STATE OF HAWAII
DEPARTMENT OF TRANSPORTATION
HIGHWAYS DIVISION

ROADWAY PLANS

FARRINGTON HIGHWAY RESURFACING

Federal Aid Project No. STP-093-1(026)

STATE OF HAWAII
DEPARTMENT OF TRANSPORTATION
HIGHWAYS DIVISION
ROADWAY PLANS
FARRINGTON HIGHWAY RESURFACING
Vicinity of Kili Drive to
Satellite Tracking Station Road
Federal Aid Project No. STP-093-K026
Scale 1"=40' Date: April, 2016
SHEET NO. 13 OF 14 SHEETS

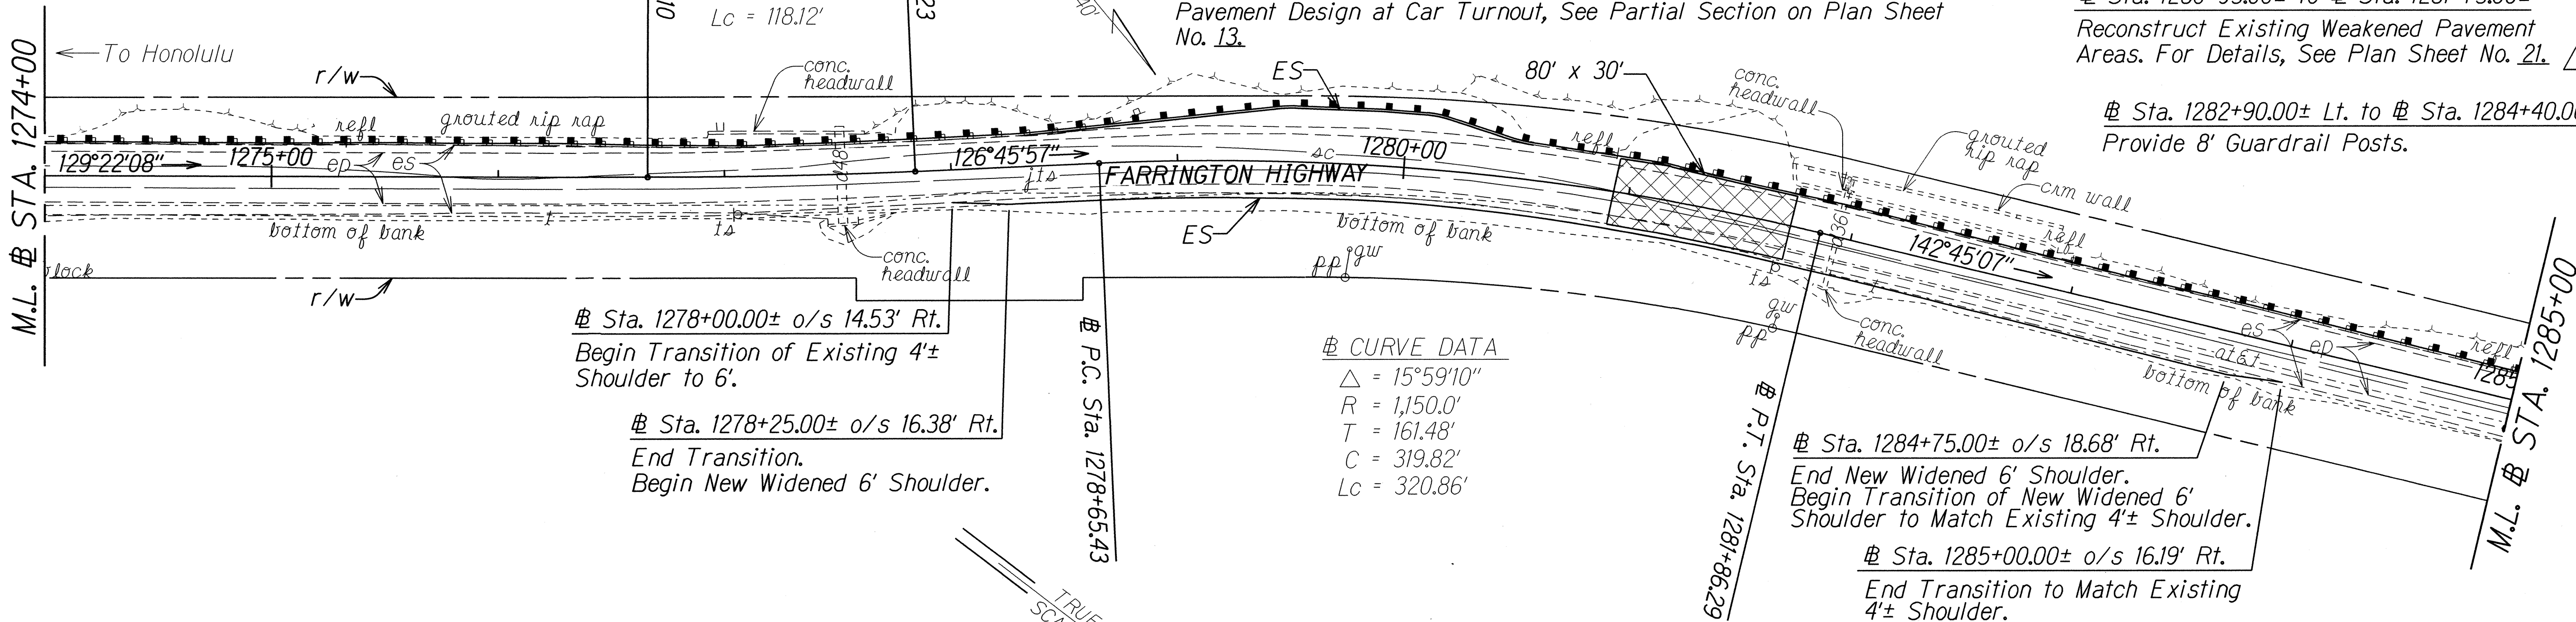
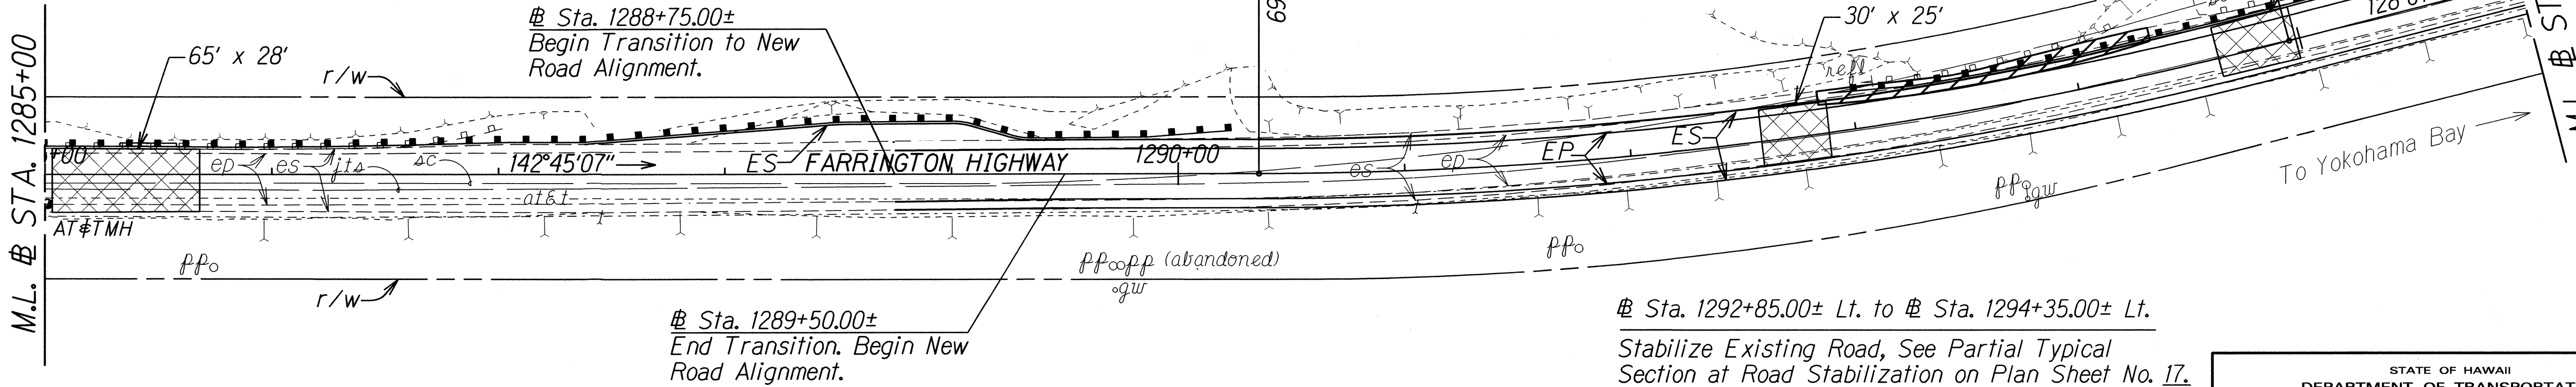
6/2/16 Revised reference sheet no. for
reconstruct existing weekend pavement
details.
Added more information to stabilize
existing road note.

Stabilize Existing Road, See Partial Typical
Section at Road Stabilization on Plan Sheet No. 17.
Contractor Shall Verify Location of Existing
Utilities Prior to Excavation, See General Notes. If
Required, Probing of Underground Utilities will be
Paid under Pay Item No. 203.0300.

SHEET No. **14** OF **14** SHEETS

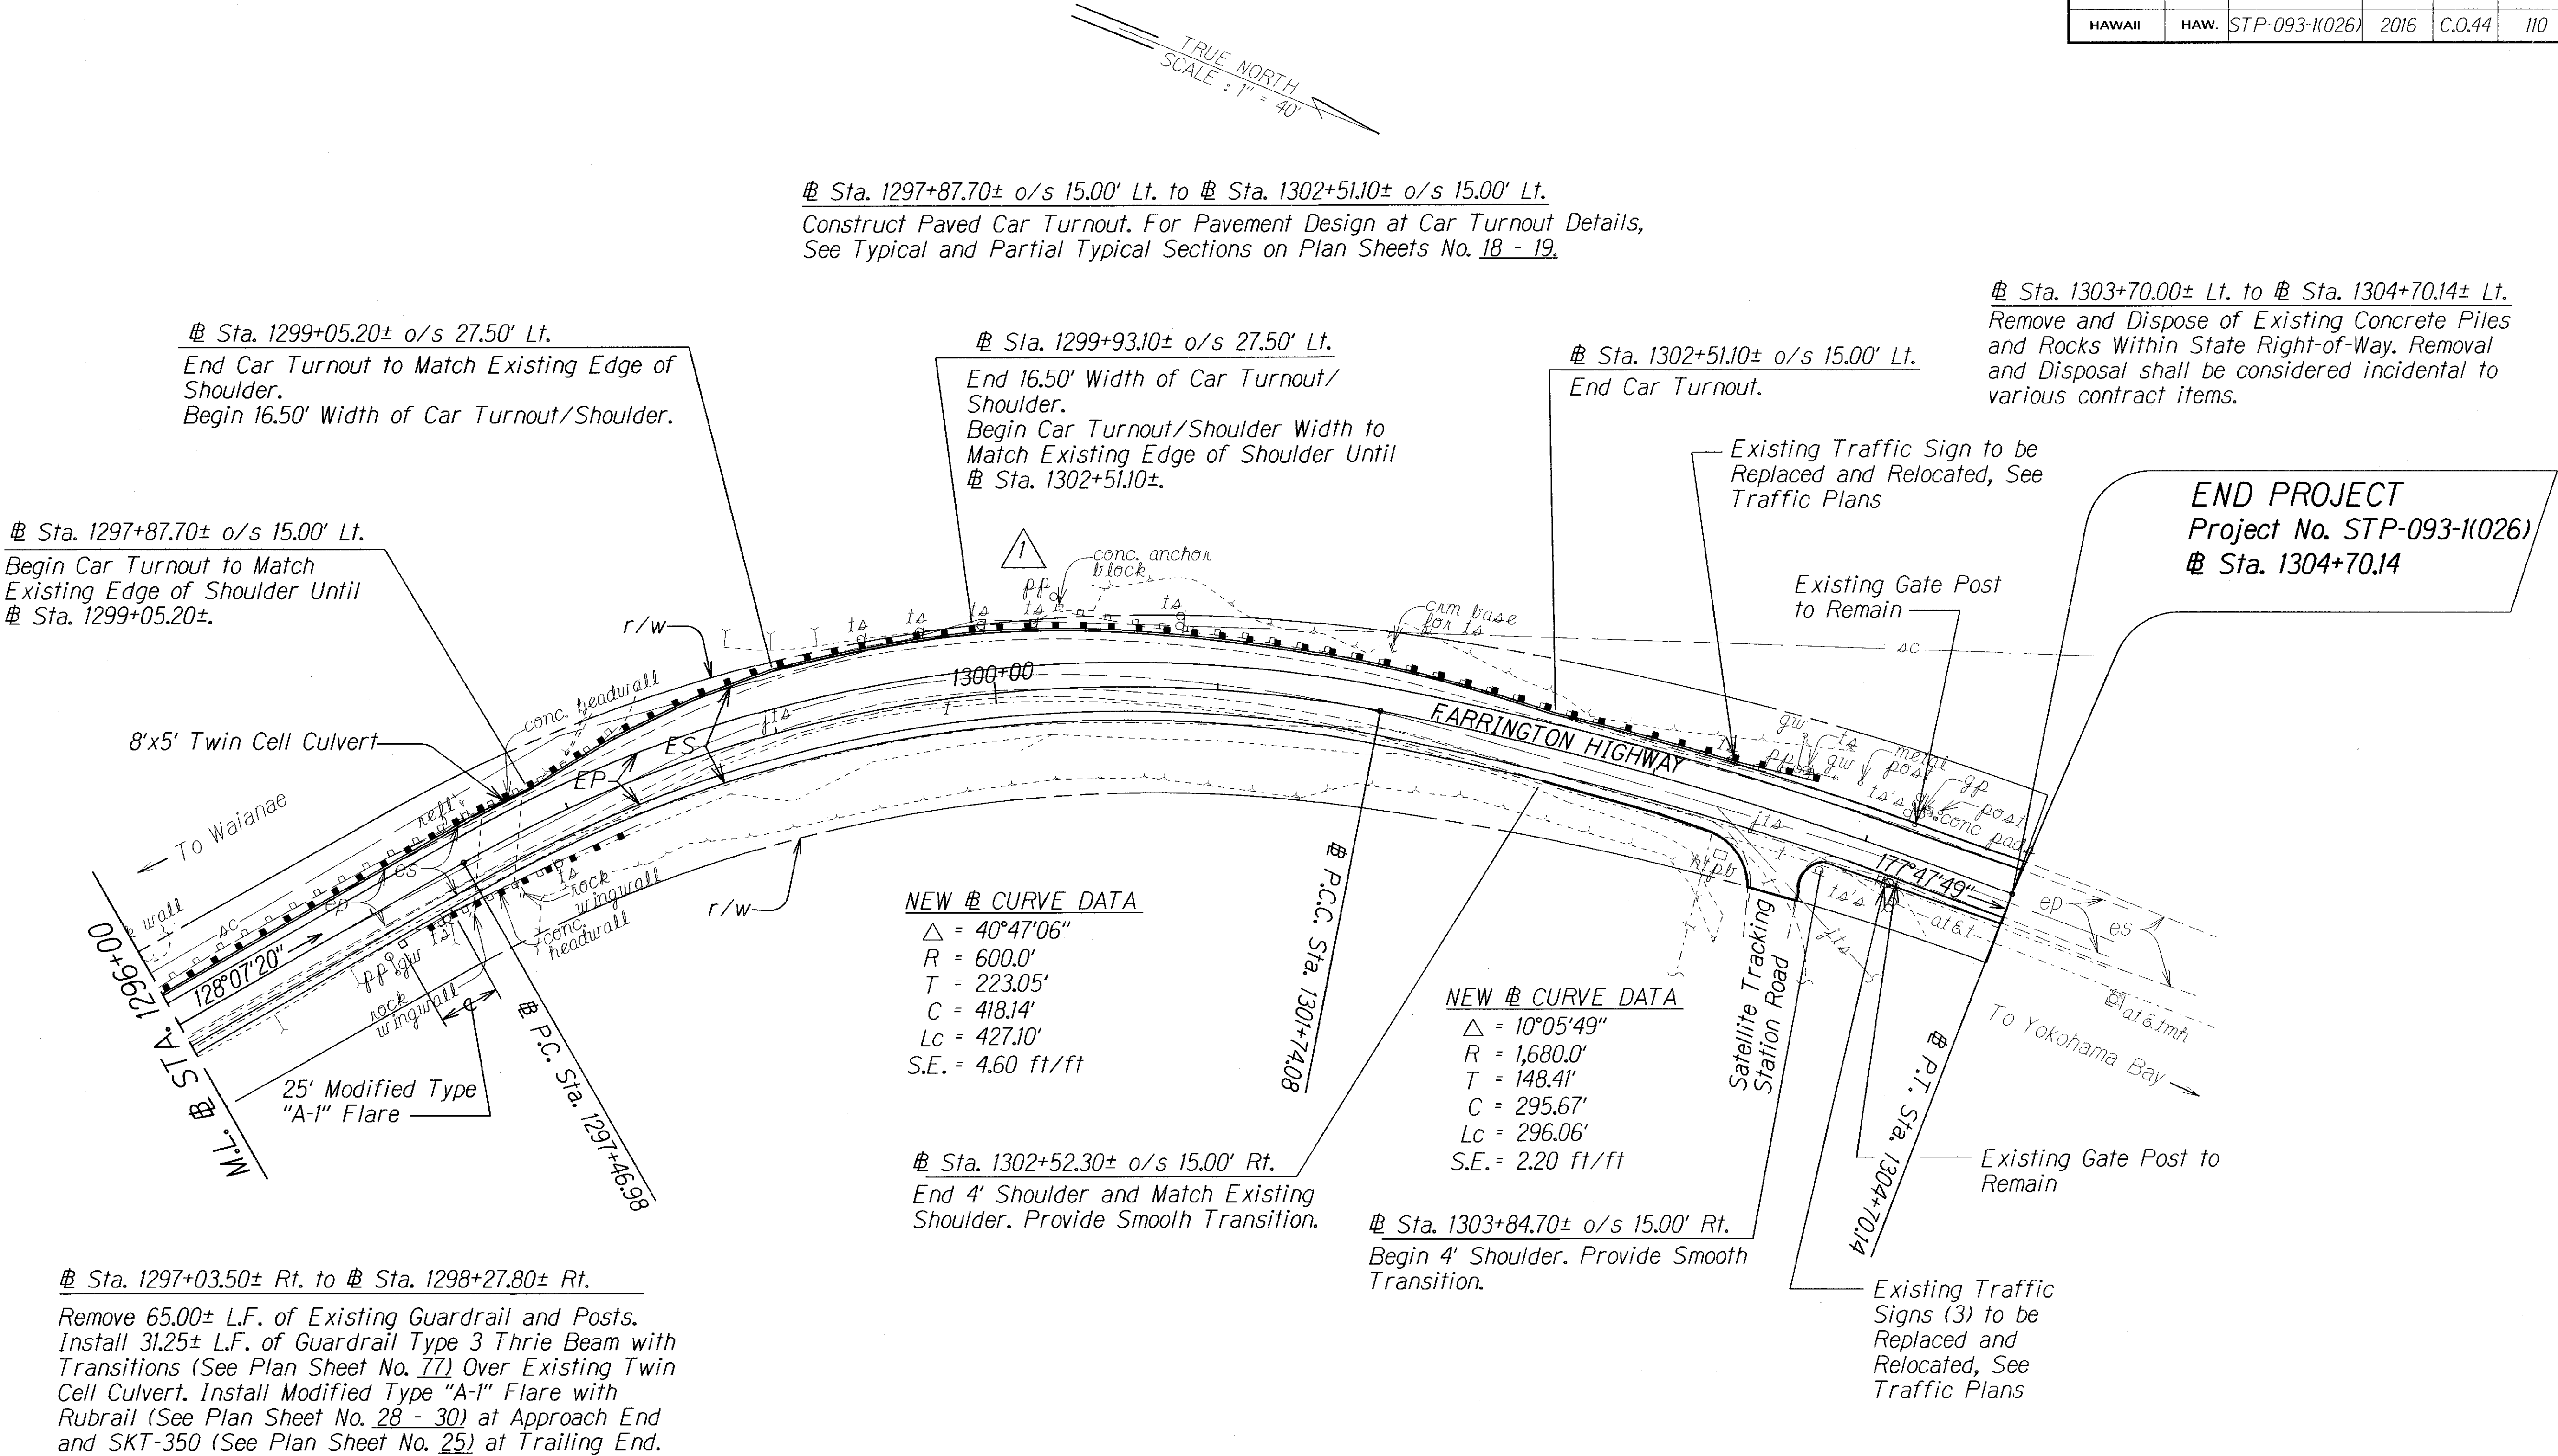
1	2/6/17	Added missing power pole.
DATE	REVISION
